APPROVED MINUTES

November 15, 2017 Standards Committee Meeting

RE: Minutes from the November 15, 2017 Standards Committee Meeting

601-R-658d (PAGE 8)MIDWEST GUARDRAIL SYSTEM ASSEMBLY LONG-SPAN(REVISED DRAFT)

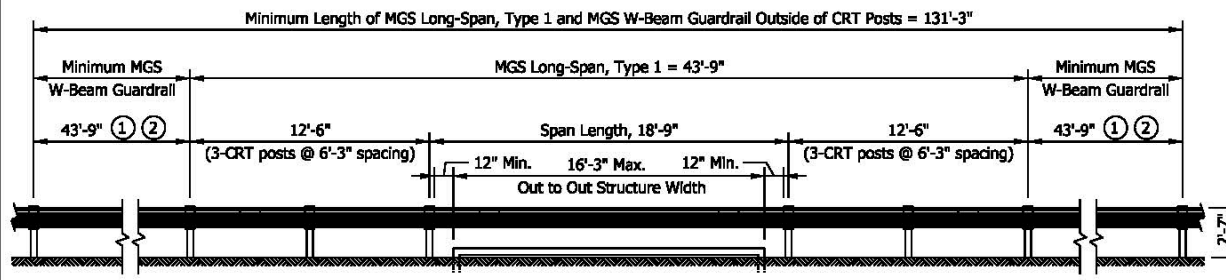
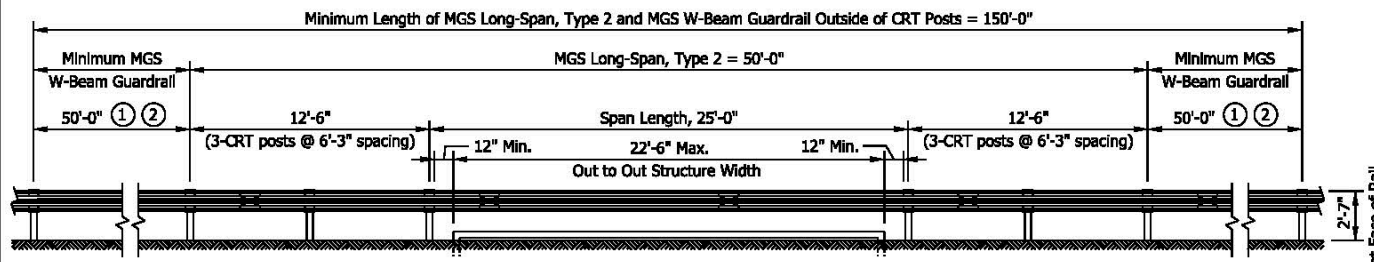
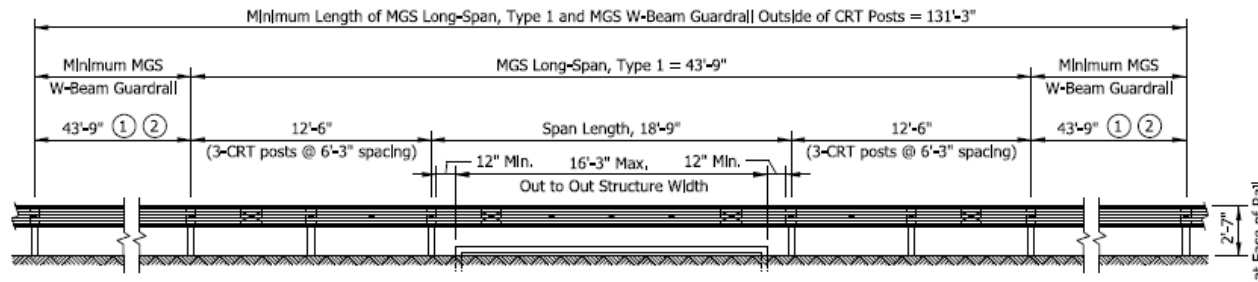
The MGS Long-Span is detailed on sheet 8 of the approved RPD 601-R-658d. The minimum length of MGS w-beam guardrail required upstream and downstream of the outermost CRT post is shown to be included with the MGS Long-Span, Type 1 and Type 2 for both the detail and the pay item. For designer and construction clarity, we believe the pay item for MGS Long-Span should only run between the outermost CRT posts and the minimum length of MGS w-beam guardrail required upstream and downstream of the MGS Long-Span should be paid for separately.

The minimum length of MGS w-beam guardrail required upstream and downstream of the outermost CRT post, may also include a guardrail end treatment, terminal end anchor, or transition. By separating the MGS Long-Span and minimum length of MGS w-beam guardrail into two pay items, it should clarify that guardrail end treatments, terminal end anchors, and transitions are paid for as each, even though they may be included in the minimum length of MGS w-beam guardrail.

Ms. Smutzer stated that, for designer and construction clarity, it is believed that the pay item for MGS Long-Span should only run between the outermost CRT posts and the minimum length of MGS w-beam guardrail required upstream and downstream of the MGS Long-Span should be paid for separately. By separating the MGS Long-Span and minimum length of MGS w-beam guardrail into two pay items, it should clarify that guardrail end treatments, terminal end anchors, and transitions are paid for as each, even though they may be included in the minimum length of MGS w-beam guardrail.

Further revisions also include revising the limits of the MGS Long-Span, Type 1 and Type 2. Adding dimensions of the minimum length of MGS w-beam guardrail required upstream and downstream of the outermost CRT posts. Editing the last sentence of Note 1 to state, "This length may include the length of a guardrail end treatment, terminal end anchor, or transition." And, removing the reference to the table in Note 1. Ms. Smutzer also proposed to revise the language in Note 1 for clarification and continuity.

PROPOSED SOLUTION: Revise sheet 8 of the approved RPD 601-R-658d by:
Changing the following description, "MGS Standard Post Spacing" to "Minimum MGS w-beam guardrail". The minimum length given on the sheet is not for MGS standard post spacing (6'-3") but for a minimum length of MGS w-beam guardrail which could include a guardrail end treatment, terminal end anchor, transition, or an omitted post in accordance with RPD 601-R-658d sheet 6.

As shown on the proposal sheet, Ms. Smutzer proposes to revise sheet 8 of the approved RPD 601-R-658d by changing the following description, "MGS Standard Post Spacing" to "Minimum MGS w-beam guardrail". The minimum length given on the sheet is not for MGS standard post spacing, 6 ft-3 in., but for a minimum length of MGS w-beam guardrail which could include a guardrail end treatment, terminal end anchor, transition, or an omitted post in accordance with RDP 601-R-658d sheet 6.

Mr. Orton revised his motion and this item passed as revised. Revised draft of the RPD 601-R-658d, sheet 8, is shown in these minutes. Revision to the 601-MGSA-08 will be reflected and will take effect in September, 2018.

FIGURE 51-9A SOUND BARRIER PLACEMENT

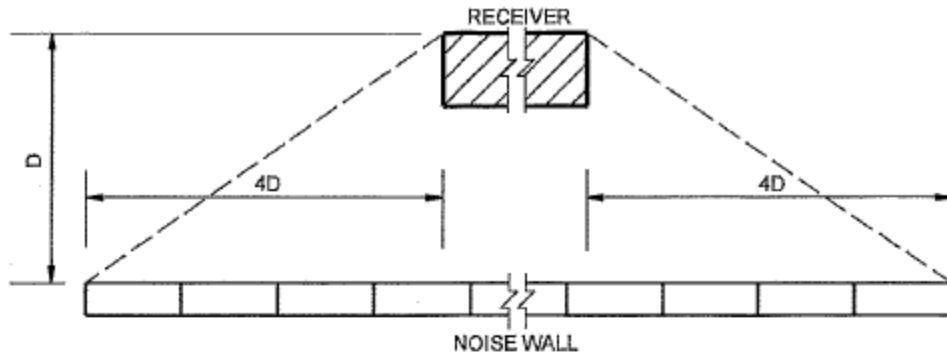
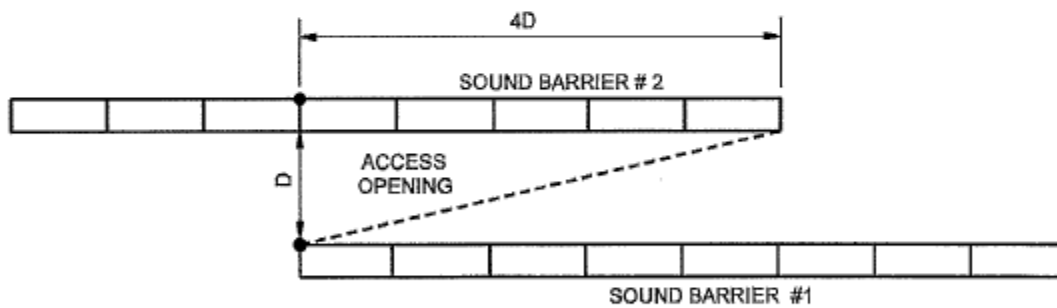
3. Length. To block the roadway noise from the sides, the ends of the barrier should exceed the receiver by four times the distance from the barrier to the receiver; see Figure [51-9A](#), Sound-Barrier Placement , detail (a).

FIGURE 51-9B SOUND BARRIER PROTRUSIONS

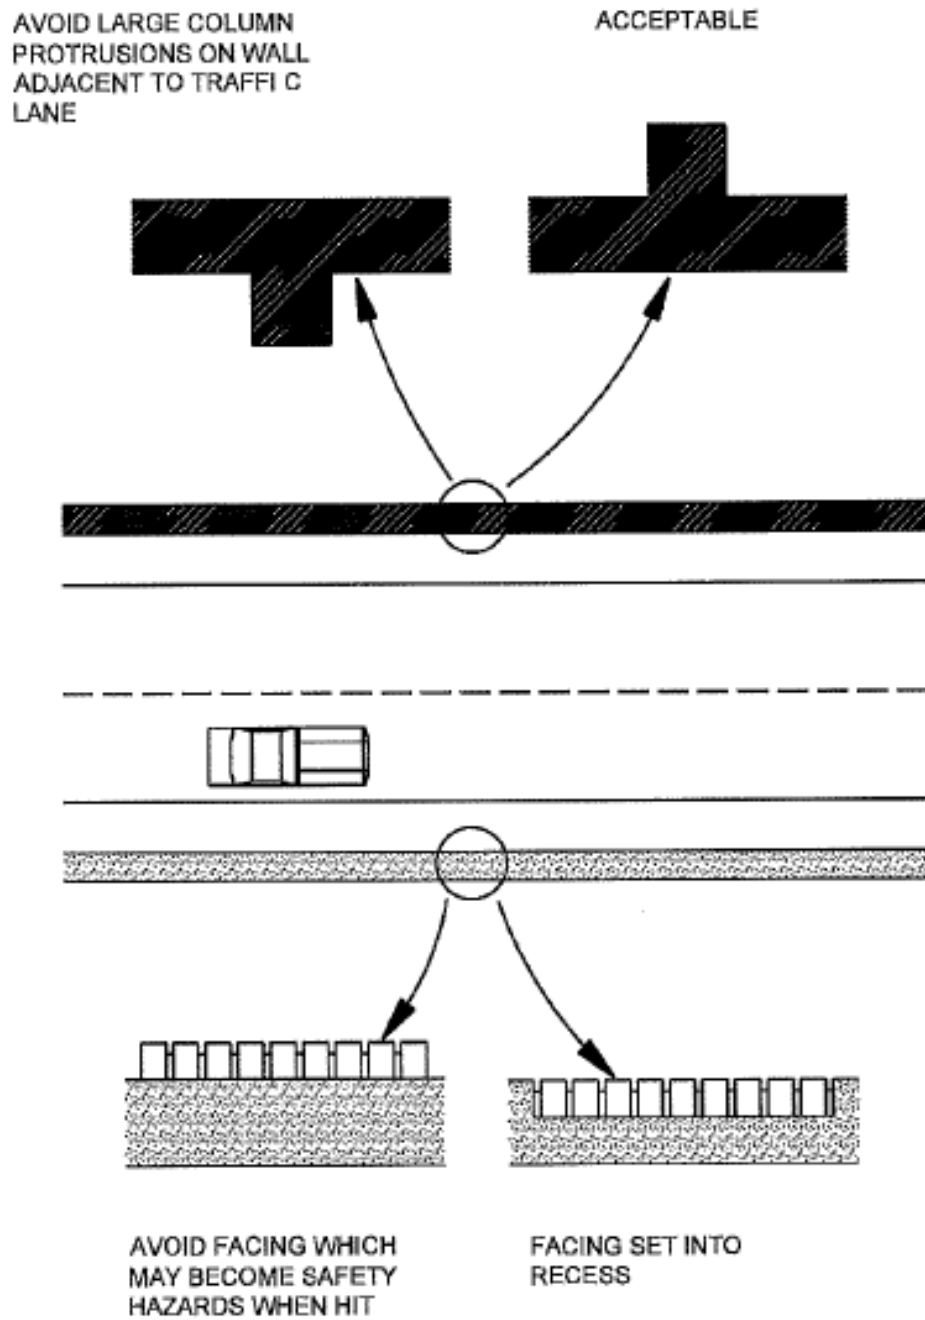
- d. Protrusion. A protrusion may become a safety hazard if it is struck or is dislodged by a vehicle. Figure [51-9B](#), Sound-Barrier Protrusions, illustrates the preferred practice for placing barrier protrusions and decorative facing.

FIGURE 51-9C BRIDGE OR WALL MOUNTED SOUND BARRIER WALL

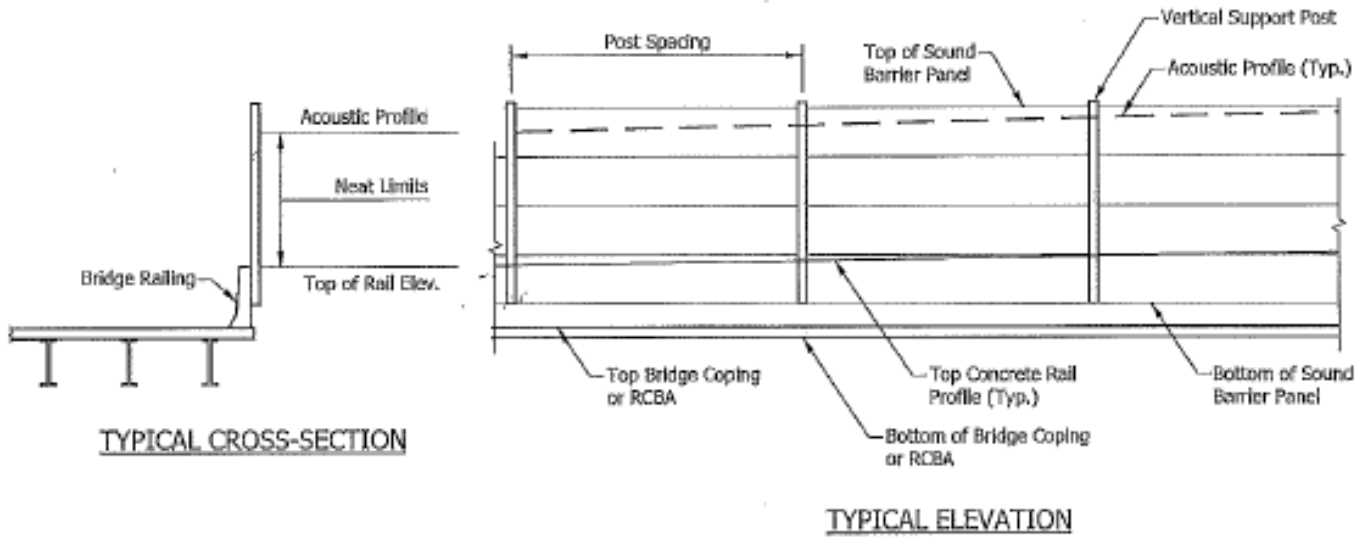
The sound barrier walls attached to the outer face of concrete bridge barrier through vertical supports are termed bridge mounted sound barrier walls, as illustrated by figure 51-9 C. Outside the bridge limits along the roadway, these can be ground mounted on independent support posts and are termed ground mounted sound barrier walls. This illustrated by figure 51-9 D.
